Access Compliance Report Public Rights-of-Way (Curb Ramps)

Intersection ID: 13115 Main Street: S MINT ST **Cross Street: WINONA_ST** Location: NE **ADA ID: 6BE469366FAD** Ramp Type: PerpDiag Initial Pass/Fail: Fail **Overall Compliance: No Severity Score:** 37.5

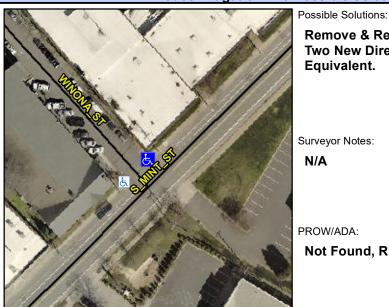
Not Found, R304.2.2, R304.5.3

Fleid Measurements/Component Compilance					
Compliance Description		Data	Compliance Description		Data
N/A	Ramp Length (in)	48.0	No	Ramp Slope (%)	13.0
Yes	Ramp Width (in)	48.0	No	Ramp XSlope (%)	6.2
N/A	Flare Type LT	N/A	N/A	Flare Type RT	N/A
N/A	Flare Slope LT (%)	N/A	N/A	Flare Slope RT (%)	N/A
N/A	Flare Traversable LT?	N/A	N/A	Flare Traversable RT?	N/A
N/A	Landing Length (in)	N/A	N/A	DWS Provided?	N/A
N/A	Landing Width (in)	N/A	N/A	DWS Contrast?	N/A
N/A	Landing Slope (%)	N/A	N/A	DWS Length (in)	N/A
N/A	Landing X Slope (%)	N/A	N/A	DWS Full Width?	N/A
N/A	Landing Curb? (Y/N)	N/A	N/A	DWS Offset (in)	N/A
N/A	Shared Landing?	N/A			
N/A	Gutter Ponding?	N/A	N/A	Gutter Slope (%)	N/A
N/A	Gutter Lip Ht (in)	N/A	N/A	Gutter X Slope (%)	N/A
N/A	Painted X Walk1?	No	N/A	Painted X Walk2?	No
	X Walk 1 Direction	To SW		X Walk 2 Direction	To SE
N/A	X Walk 1 Width (in)	N/A	N/A	X Walk 2 Width (in)	N/A
	X Walk 1 Slope (%)	1.8		X Walk 2 Slope (%)	5.3

Remove & Replace Curb Ramp With **Two New Directional Ramps or** Equivalent.
